Applicant:	Conrad Hurst
Property Owner:	STC Morse, LLC STC 216, LLC (Frontier Dev.)
Location:	Southeast corner of Riverside Ave. and Illinois Ave.
Purpose:	Receive feedback on Concept Plan
Application:	Concept Plan
Public Hearing:	Not required
Zoning:	CBD-1 Central Business District & Downtown Overlay
Current Land Use:	Office building, parking lot and bank ATM
Comprehensive Plan:	Mixed Use

River East Apartments

Summary of Proposal:	<p>Conrad Hurst of Frontier Development, as property owner, has filed a Concept Plan proposing:</p> <ul style="list-style-type: none"> • Mixed-Use building with ground floor commercial and parking, and upper floor residential apartments (48 units) • Closure of Indiana Ave. and use of City-owned grass area to the south for street parking and open space
Info / Procedure on Application:	<ul style="list-style-type: none"> • Per Sec. 17.04.140, the purpose of the Concept Plan review is as follows: “to enable the applicant to obtain informal input from the Plan Commission and Council Committee prior to spending considerable time and expense in the preparation of detailed plans and architectural drawings. It also serves as a forum for owners of neighboring pr

AERIAL SITE PLAN AND
OVERALL SITE PLAN

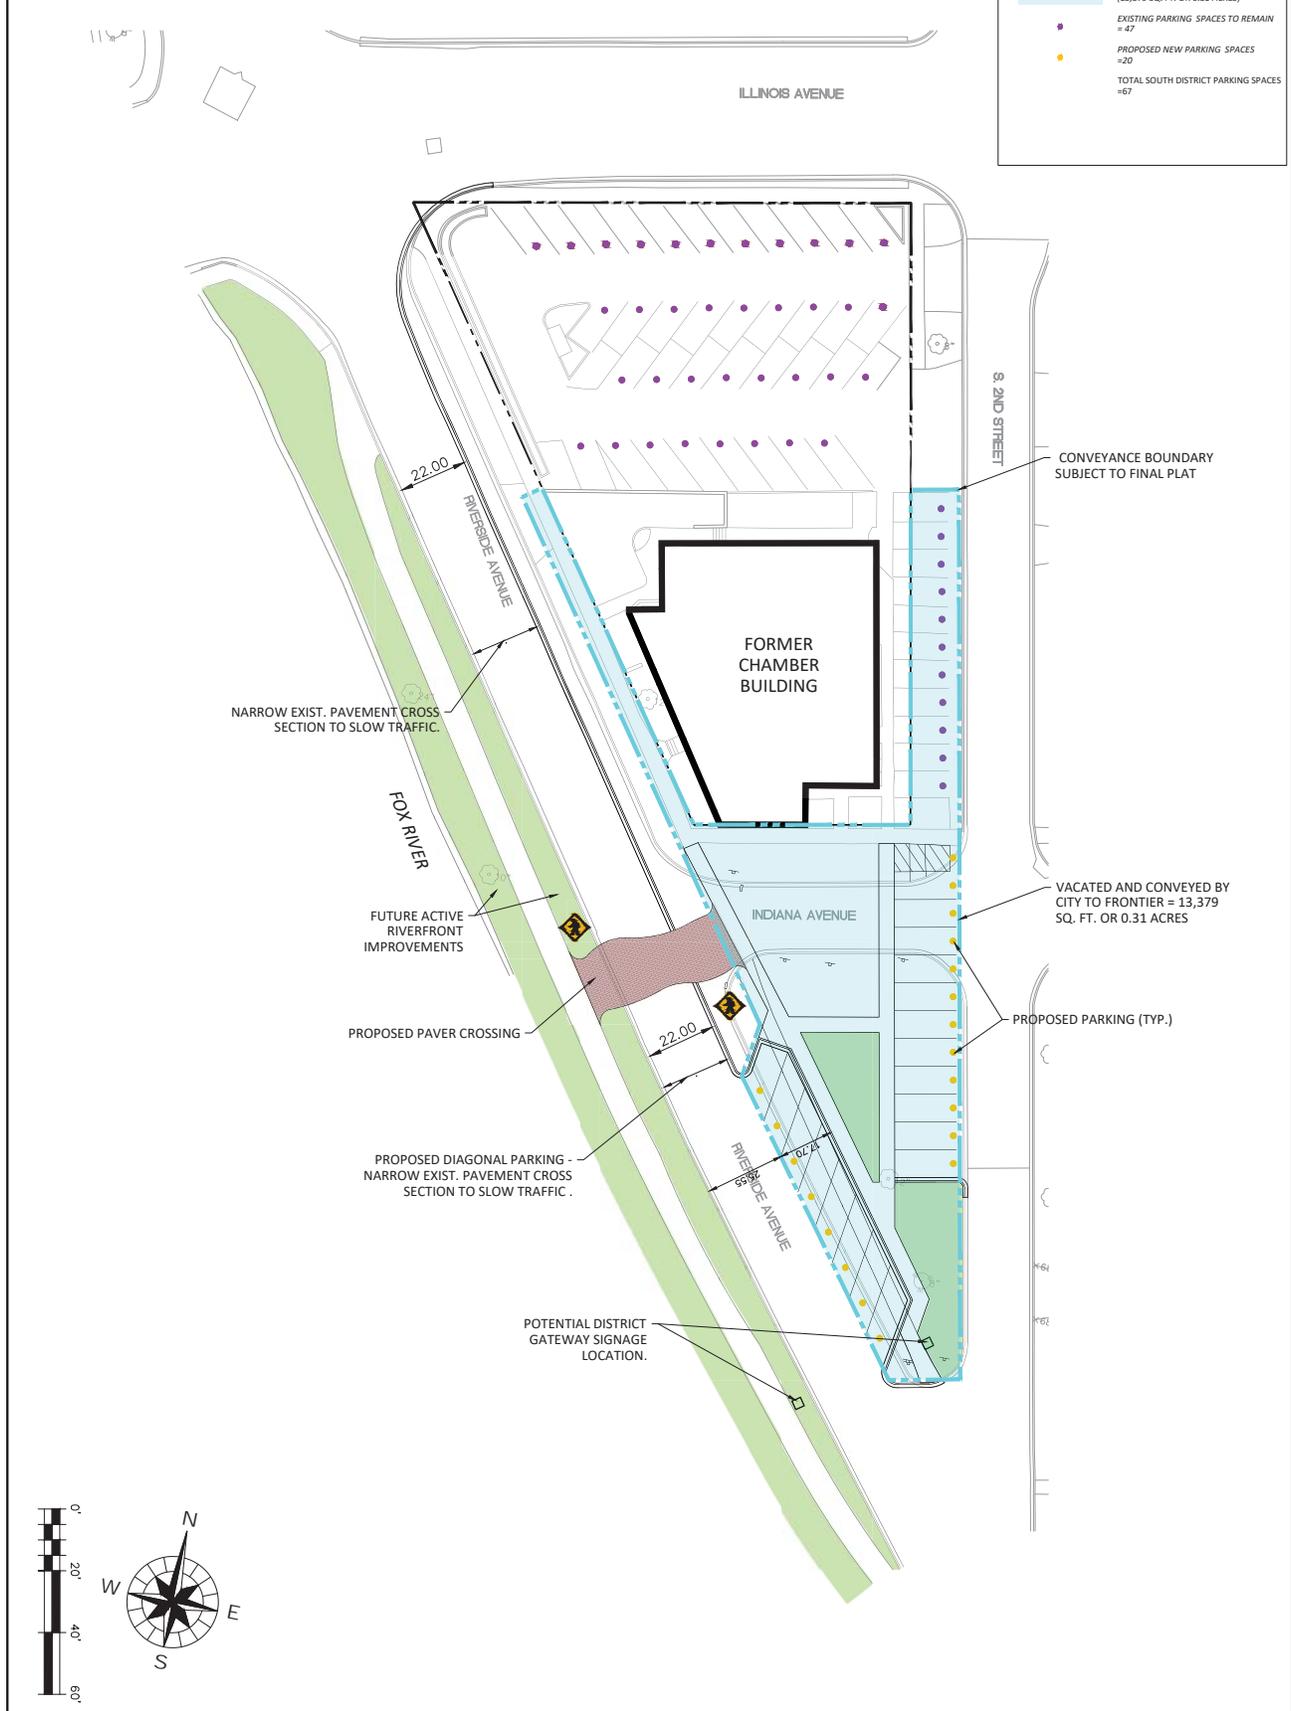
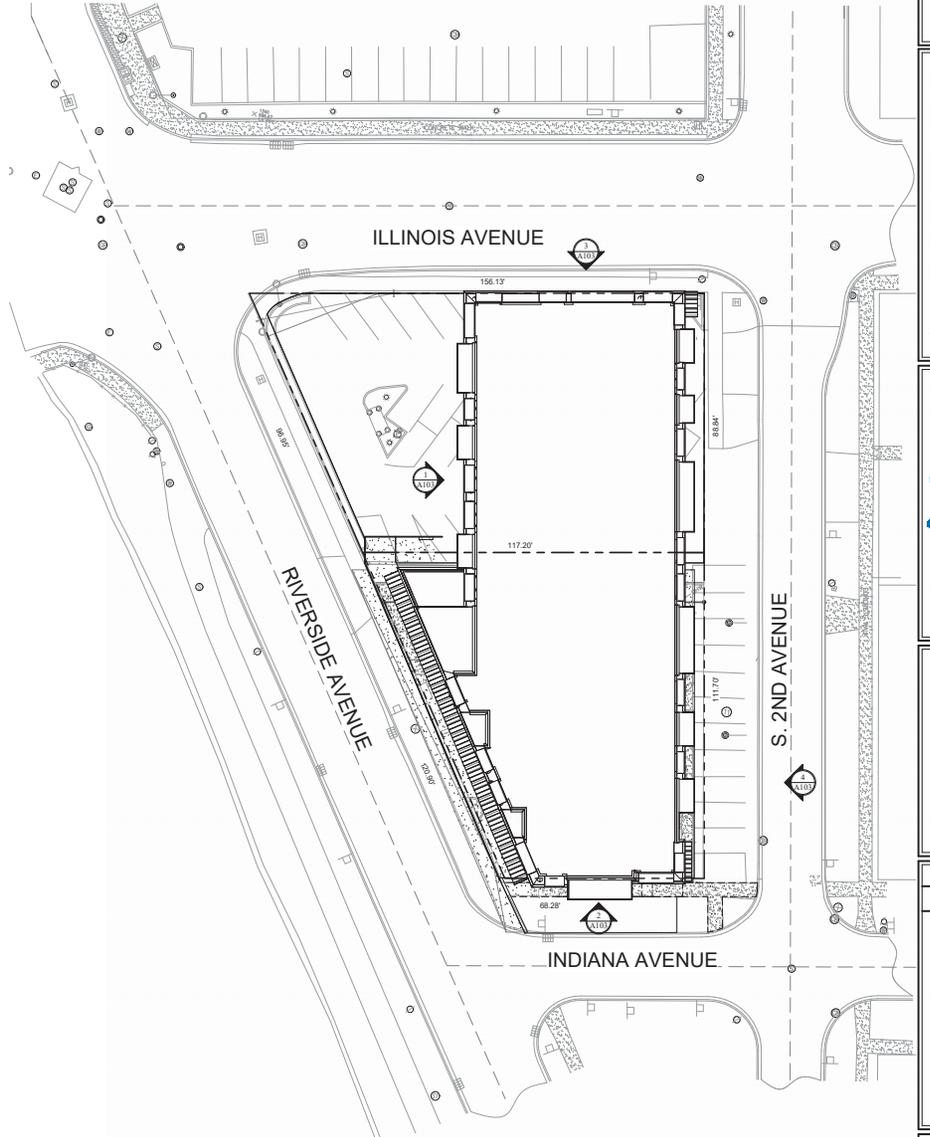
The Concept Plan shows closure of Indiana Ave., narrowing of Riverside Avenue, and addition of parking stalls along both 2nd Ave. and Riverside Ave.

- ✓ Left turns from northbound 2nd Ave. to Illinois Ave. are restricted. This may need to be reevaluated given the proposed change to the street network.
- ✓ An intersection site visibility issue may be created by the proposed building. This will require evaluation.

- ✓ The street is currently 22 ft. wide. A 24 ft. width is preferred due to traffic volumes.

- ✓ Proposed width of 22 ft. will require further evaluation. A 24 ft. width is preferred due to traffic volumes.
- ✓ Angled parking on Riverside Avenue may pose safety issues, including backing up into traffic on a busy roadway and line of sight problems for traffic at 2nd Ave and Riverside. The northbound traffic lane may need to be a minimum of 12 ft. wide to keep vehicles from backing up into the oncoming traffic lane.
- ✓ Proposed paver crossing will require further evaluation, as this would be a mid-block crossing. A traffic signal-controlled crosswalk is provided at Illinois, and a signed and striped pedestrian crossing is provided at the 2nd Avenue intersection.

- ✓ ATM usage may create conflicts with the parking lot, as the lot will be more consistently utilized.
